APPLICATION NO.	FILING DATE	FIRST NAMED INVENTOR	ATTORNEY DOCKET NO.	CONFIRMATION NO.
10/791,323	03/02/2004	Edward Aloysius Fitzgerald	309.030	1825
	7590 06/14/2007 PRICKSON NEWHOLM	EXAMINER ·		
250 E. WISCO	NSIN AVENUE	ROMAN, LUIS ENRIQUE		
SUITE 1030 MILWAUKEE	. WI 53202	ART UNIT	PAPER NUMBER	
	,		2836	
			NOTIFICATION DATE	DELIVERY MODE
			06/14/2007	ELECTRONIC .

Application No.	Applicant(s)				
		10/791,323	FITZGERALD ET AL.				
	Office Action Summary	Examiner	Art Unit				
		Luis Roman	2836				
The MAILING DATE of this communication appears on the cover sheet with the correspondence address Period for Reply							
A SHORTENED STATUTORY PERIOD FOR REPLY IS SET TO EXPIRE 3 MONTH(S) OR THIRTY (30) DAYS, WHICHEVER IS LONGER, FROM THE MAILING DATE OF THIS COMMUNICATION. - Extensions of time may be available under the provisions of 37 CFR 1.136(a). In no event, however, may a reply be timely filed after SIX (6) MONTHS from the mailing date of this communication. - If NO period for reply is specified above, the maximum statutory period will apply and will expire SIX (6) MONTHS from the mailing date of this communication. - Failure to reply within the set or extended period for reply

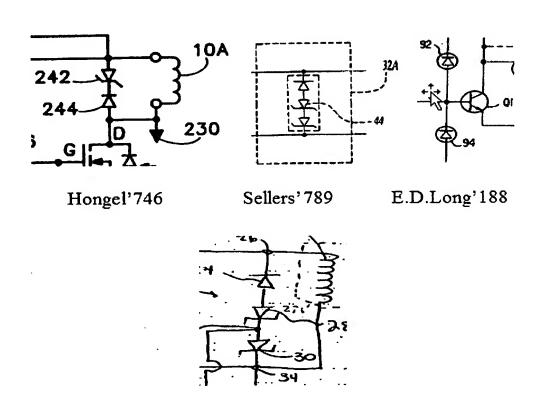
- 1) The cathode of the first Zener diode is connected to a coil;
- 2) the input of a driver is operatively connected to the anode of the first Zener diode;
- 3) a reference voltage is generated across the first Zener diode by de-energization of the coil; and
- 4) the driver closes the first solid state switch in response to the reference voltage across the first zener diode (Col. 11 lines 44-63 & Col. 13 lines 10-45< Here it is

explained the operation of diodes 242 & 244 in conjunction with the switches 26 to avoid arcing).

Following the sequence of drawings below and rejection of claim 1 will help to understand the combination.
